PROPOSAL

Install tree wells and plant Mountain Laurels in the sidewalk along Trinity Street (right-of-way next to the Cotton Exchange building, C14H-1978-0008)

City of Austin
Historic Landmark Commission
NRD-2010-0041 401 East 6th St.

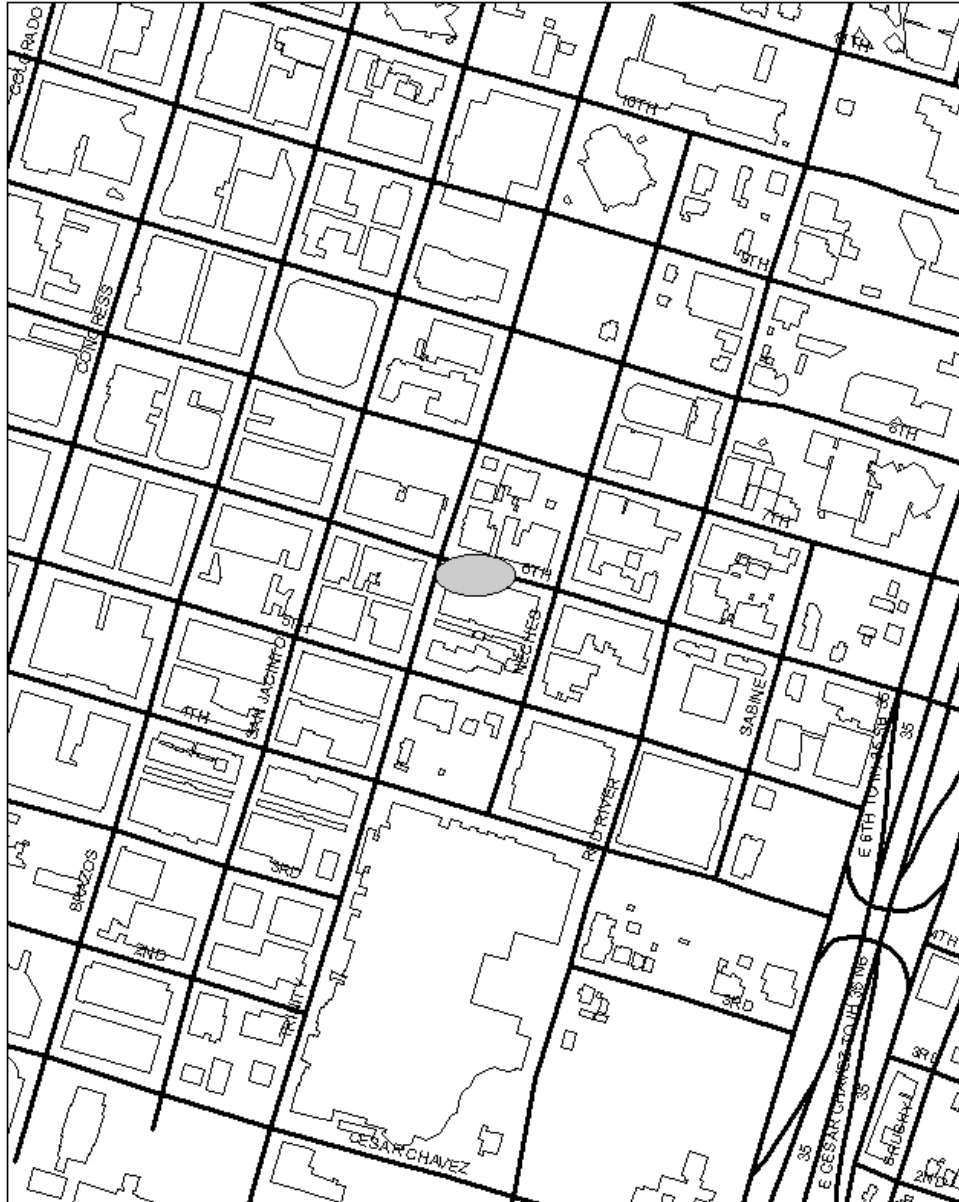
This application was reviewed by the City's Historic Preservation Office (CHPO) on two occasions; however, the tree wells were not a part of the design reviewed and approved by CHPO staff. The Historic Preservation Officer visited the site to make recommendations and approve work being completed on the utilities and in the sidewalk following the initial sign-off.

Before the project was released, but after the CHPO sign-off, the decision was made to chose Mountain Laurels, necessitating the tree well planters. In order to complete the project so that construction would not impede visitors to the South by Southwest Festival, the applicant started work after finishing several City reviews but without obtaining an additional sign-off from the CHPO after the re-design introduced the tree wells.

Staff appreciates the difficulty in obtaining approval for projects with multiple review entities in unusual situations where project parameters are changing and there are potentially conflicting goals; however, the obligation remains with the applicant to obtain all necessary sign-offs before beginning construction. The applicant maintains their team worked closely with the city on all aspects of this project and had no intention of disrespecting the city's processes in any way.

Given the fact that the tree wells are built with limestone, in a manner complementary to the limestone Cotton Exchange Landmark building, and in recognition that another unit of the city recommended the tree wells, staff recommends approval as submitted.
